Safety Evaluation Report for the American Centrifuge Plant in Piketon, Ohio

Docket No. 70-7004

USEC, Inc.

Figure 1-1 Simplified Base Curve Recommended for Calculation of CRR From the Standard Penetration Test Results (Modified from National Center for Earthquake Engineering Research, 1997)

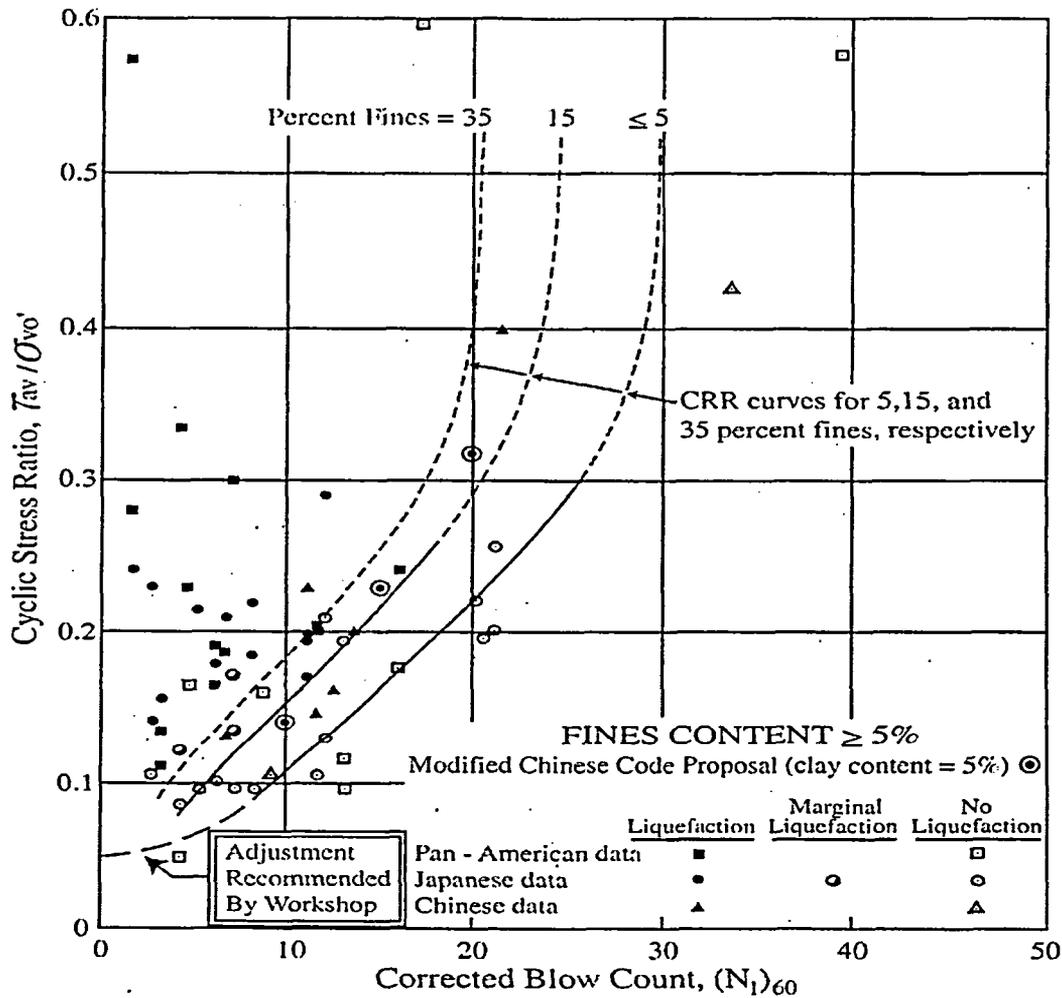
For earthquakes of different magnitudes, the CRR curves shown in Figure 1 must be scaled up or down on the diagram. The suggested magnitude scaling factors can be found in NCEER (NCEER, 1997). According to the LA (USEC, 2006c) and the ISA Summary (USEC, 2006b), the general DBE for the proposed ACP except the X-3346 building Customer Service Area has a Richter magnitude of 5.25 with a horizontal peak ground acceleration of 0.15g. The

magnitude scaling factor for this earthquake magnitude is at least 1.43. The magnitude scaling factor of 1.43 is suggested for an earthquake of magnitude 5.5 and may be considered as a bounding value compared with the values suggested by other researchers (Table 3, NCEER, 1997). Applying this scaling factor, the CRR curves in Figure 1-1 represent a safety factor of at least 1.43 for earthquakes of magnitude 5.25.

Figure 3-1a ISA for the ACP

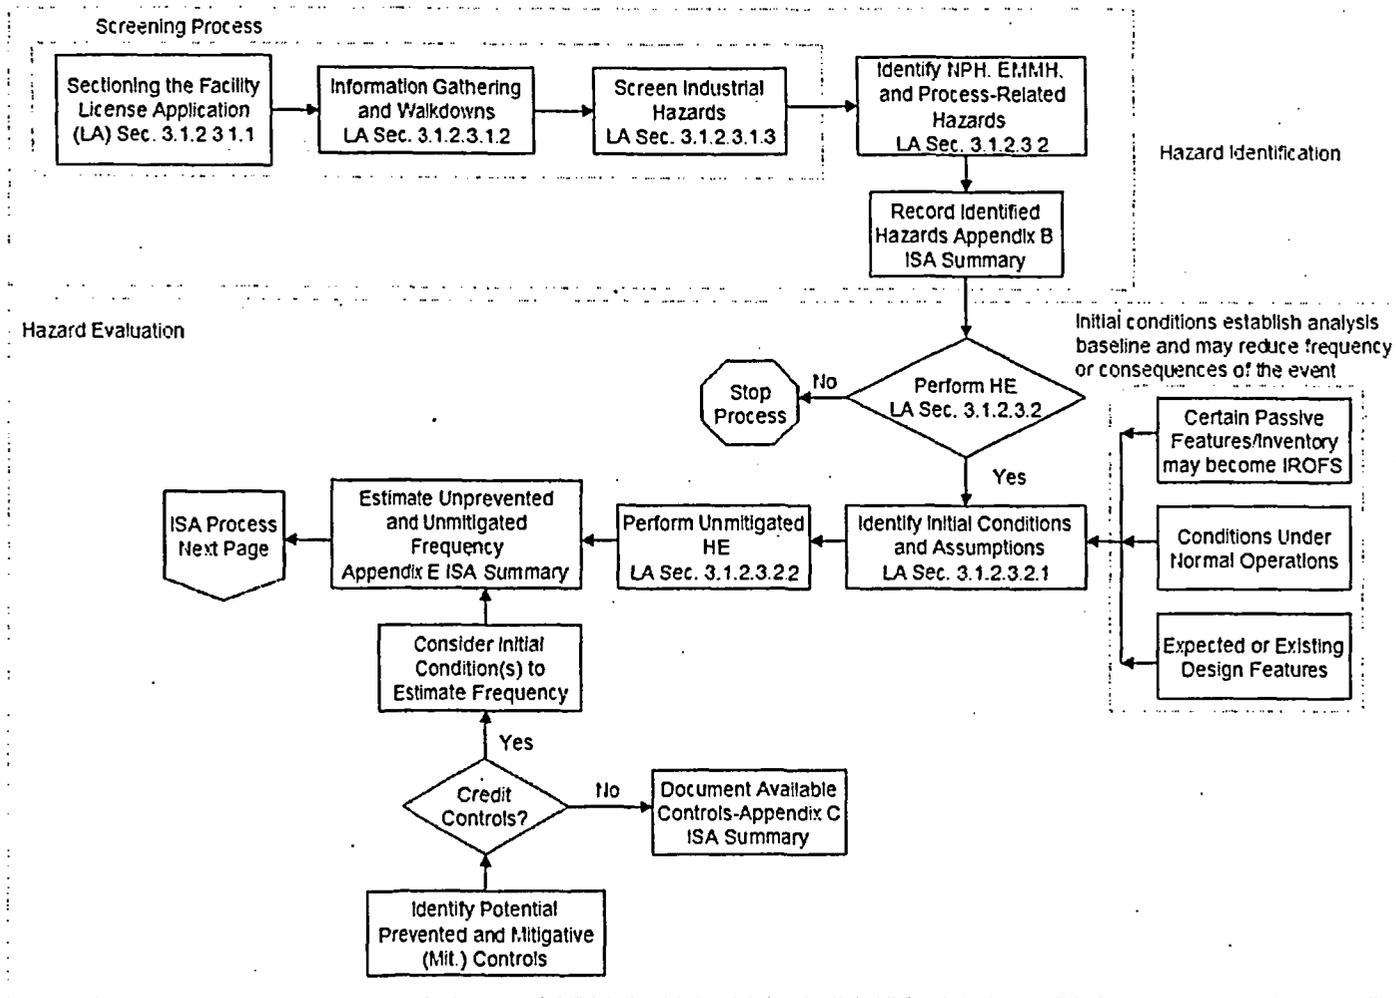
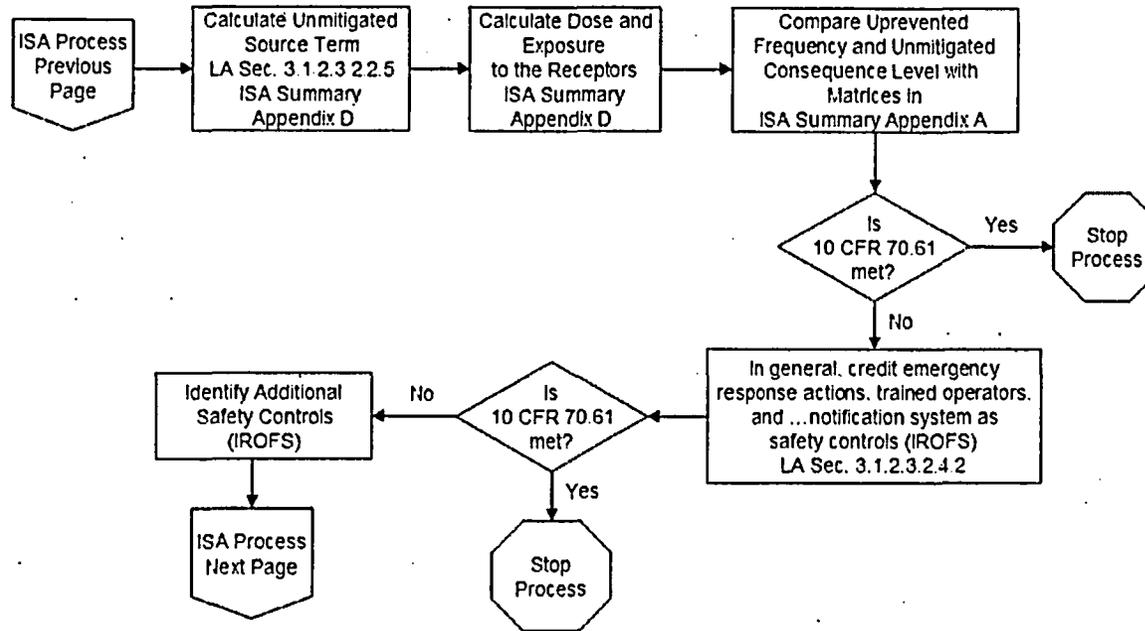
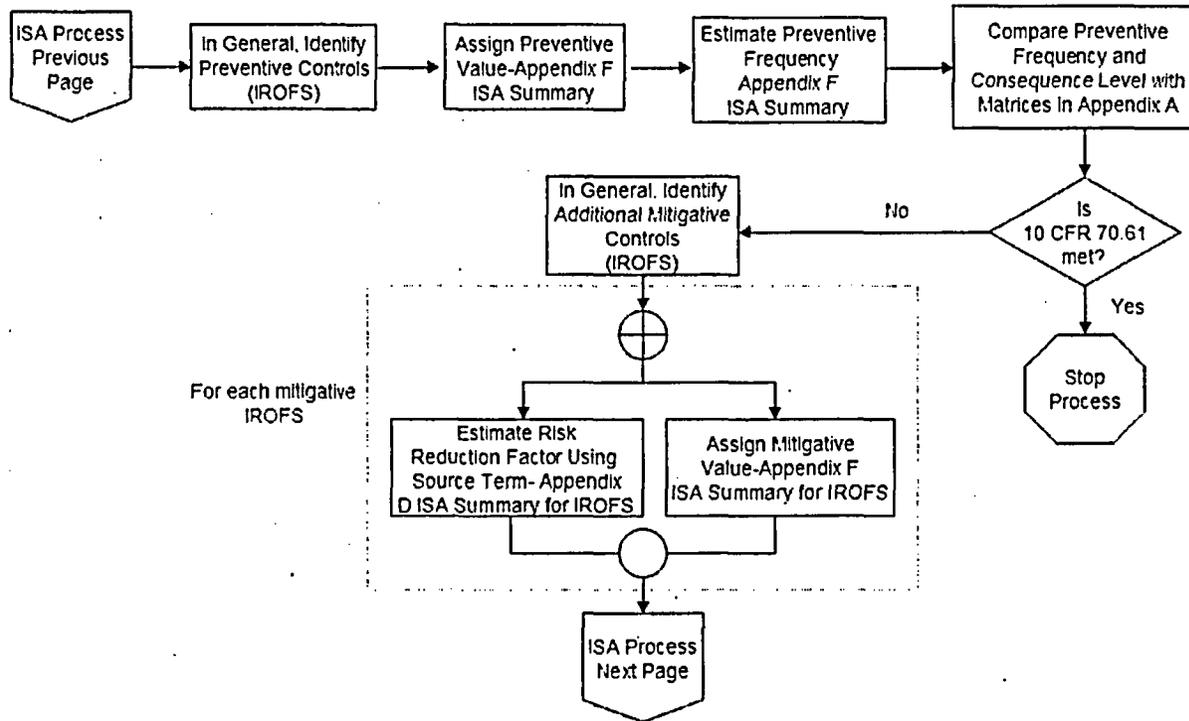
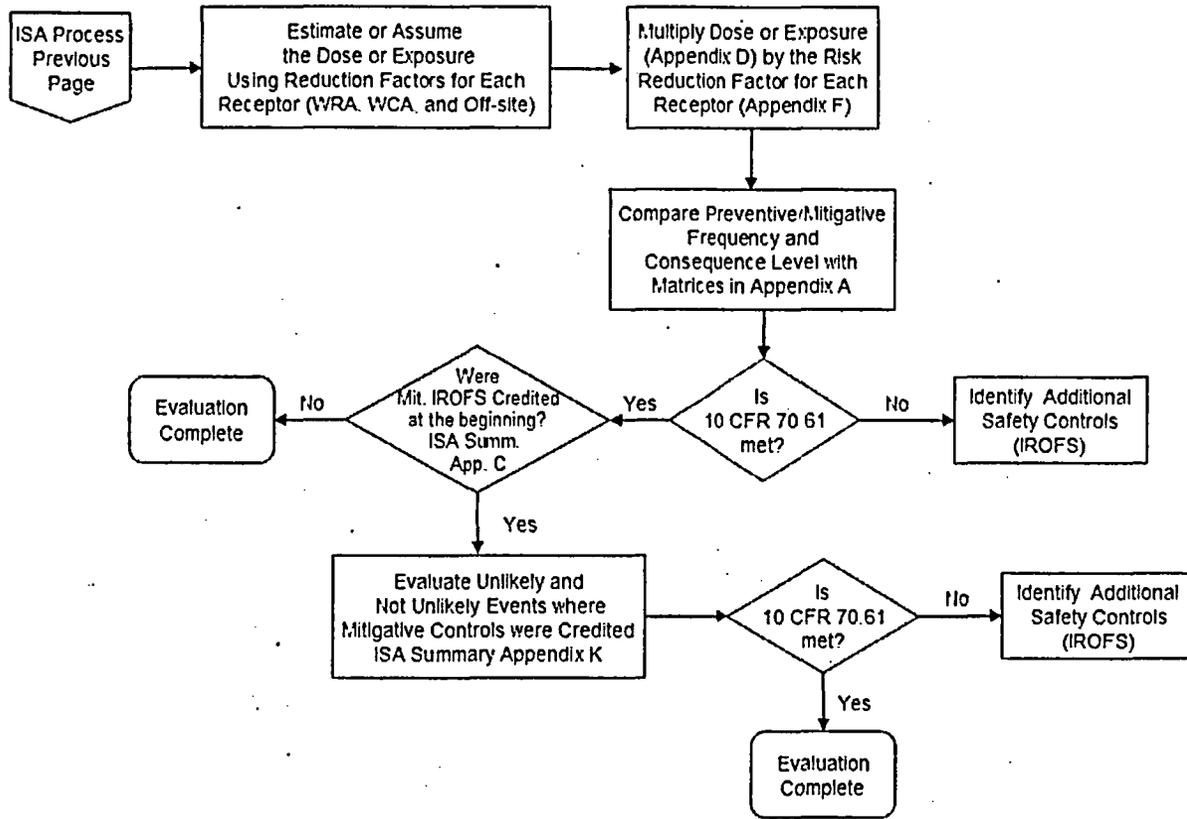
The hazard analysis for the ISA is developed using two primary activities: (i) hazard identification and (ii) hazard evaluation. These activities result in the estimates of consequences and frequencies such that scenarios can be identified that have a potential risk to the public, workers, and the environment that exceeds the 10 CFR 70.61 performance requirements. The hazard identification process is shown in the top boxed-in set of ISA process steps in Figure 3-1a. The hazard evaluation process is comprised of the rest of the process steps shown in Figures 3-1a - 3-1d.

If the 10 CFR 70.61 performance criteria are not satisfied, the process progresses as shown at the start of the process as shown in Figure 3-1c where available preventive controls are credited to meet the performance requirements. These controls are selected in an order of preference. If available, engineered or designed controls will be selected before administrative controls, to use the inherent reliability advantage of designed systems or components over that of required human action compliance. Defense-in-depth concepts using non-credited controls were also incorporated into the control strategy for a postulated event whenever possible according to Section 3.1.2.3.2.4 of the LA (USEC, 2006b). These defense-in-depth controls are generally controls that were listed as available when the sequences were formulated but not explicitly required to meet the performance requirements.

The final steps in the ISA analysis are shown in Figure 3-1d. This step of the analysis evaluates the likelihood of failure of mitigative IROFS for events that are not prevented or made to be "highly unlikely." Events for which mitigative controls were credited were evaluated to examine the residual risk associated with the postulated failure upon demand of each mitigative IROFS. The approach used in the evaluation developed a series of sub-events designed to demonstrate that the risk of the event after failure of one or more mitigative controls is still within the 10 CFR 70.61 performance requirements. This evaluation is described and tabulated in Appendix K of the ISA Summary (USEC, 2006a).
